NOTE: PLAN REVIEW EXCLUDES  
MECHANICAL, ELECTRICAL, AND  
PLUMBING REVIEW PER 2017 FBC  
A107.3.5 FIELD INSPECTOR  
WILL VERIFY COMPLIANCE WITH  
ALL APPLICABLE CODES.

LOT 43 ROLLING MEADOWS

## SPARKS CONSTRUCTION

REVIEWED FOR  
CODE COMPLIANCE  
UNIVERSITY OF FLORIDA  
NOV 20 2019  
Larry Hogan SFP 304  
EXAMINER - LICENSE NO.

## A.1

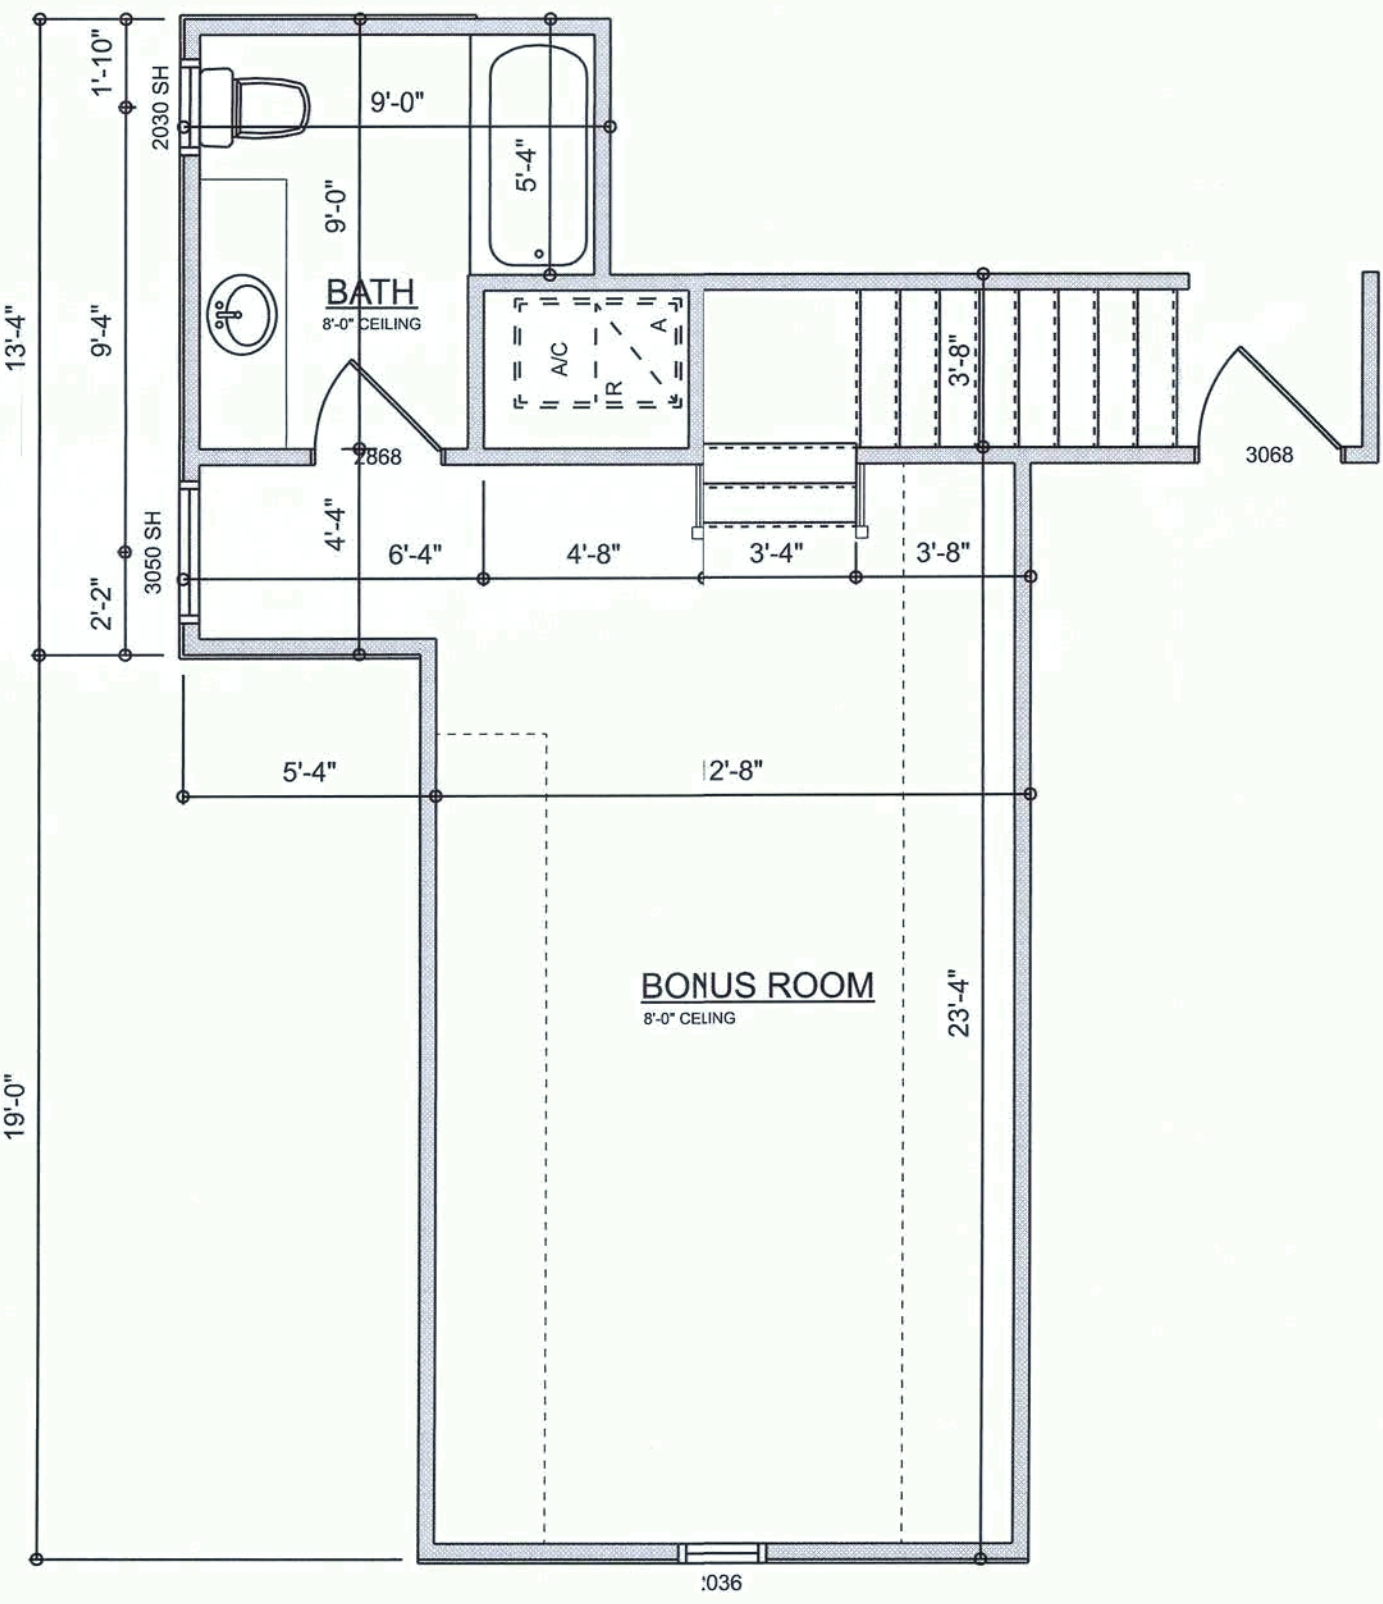
E3901.6 GFI required within 36" of the outside edge of each lav. basin

ELECTRICAL PLAN NOTES:

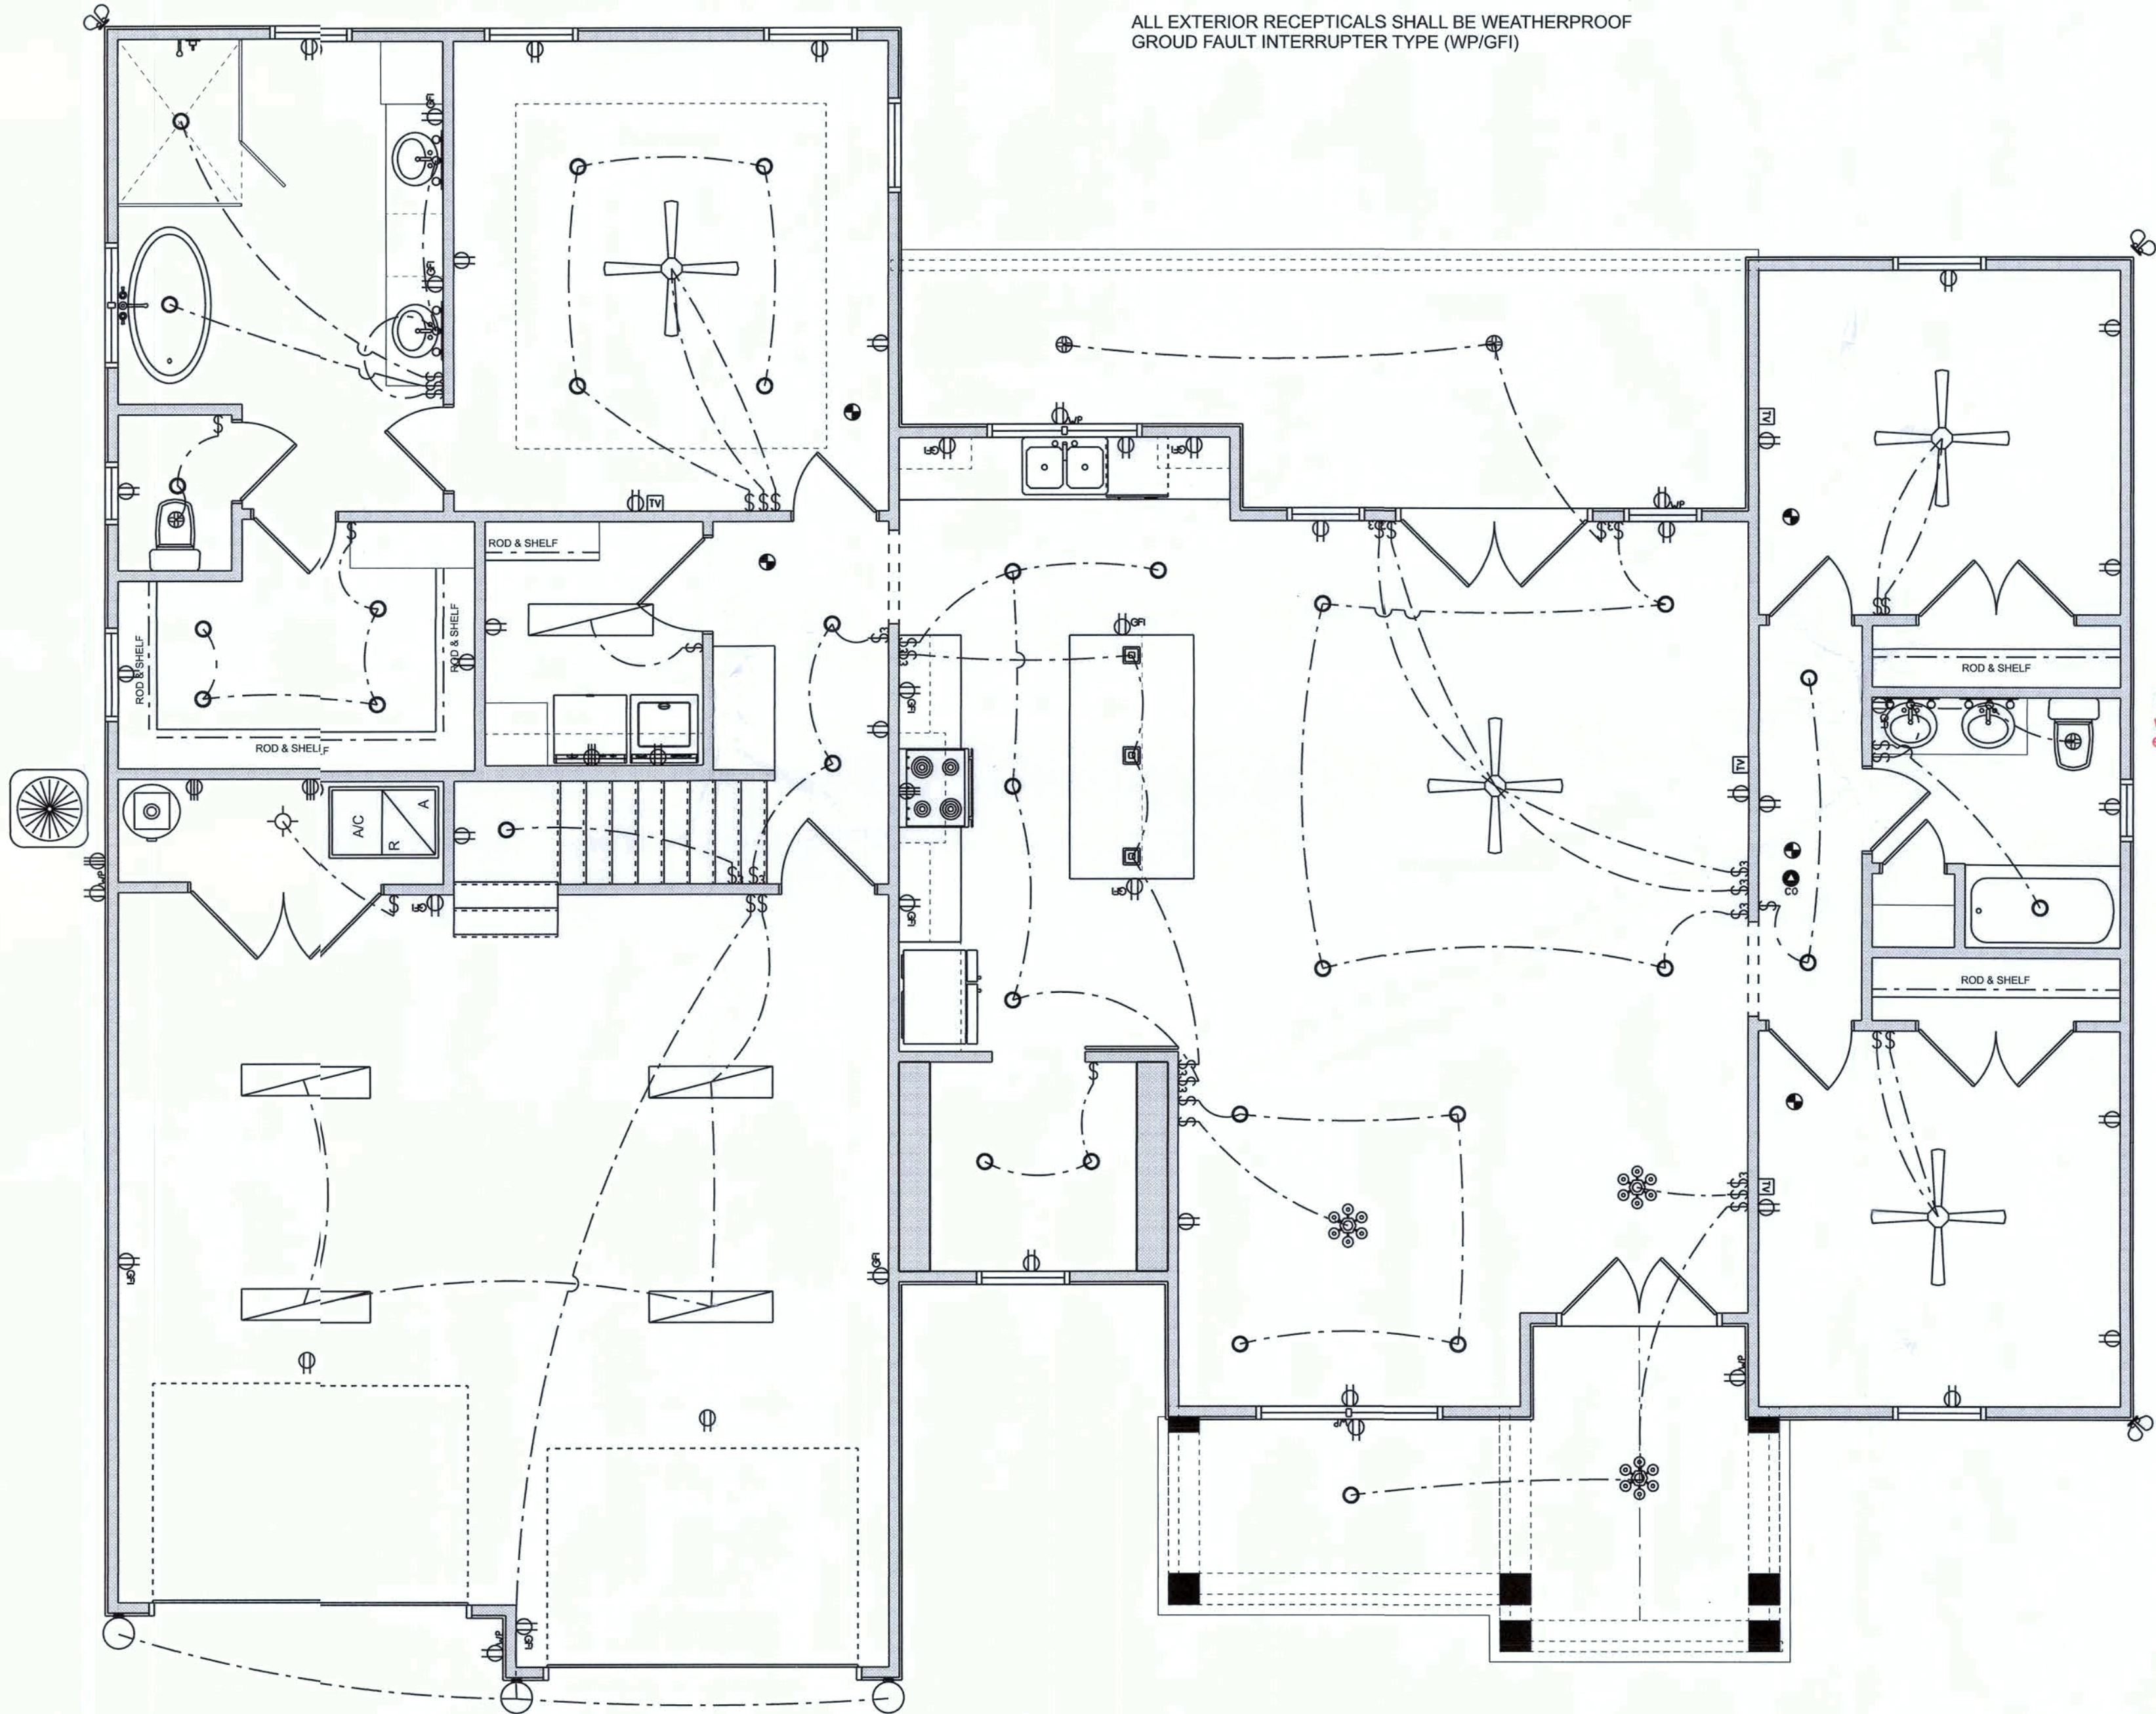
E3901.6 GFI required  
within 36" of the outside  
edge of each lav. basin
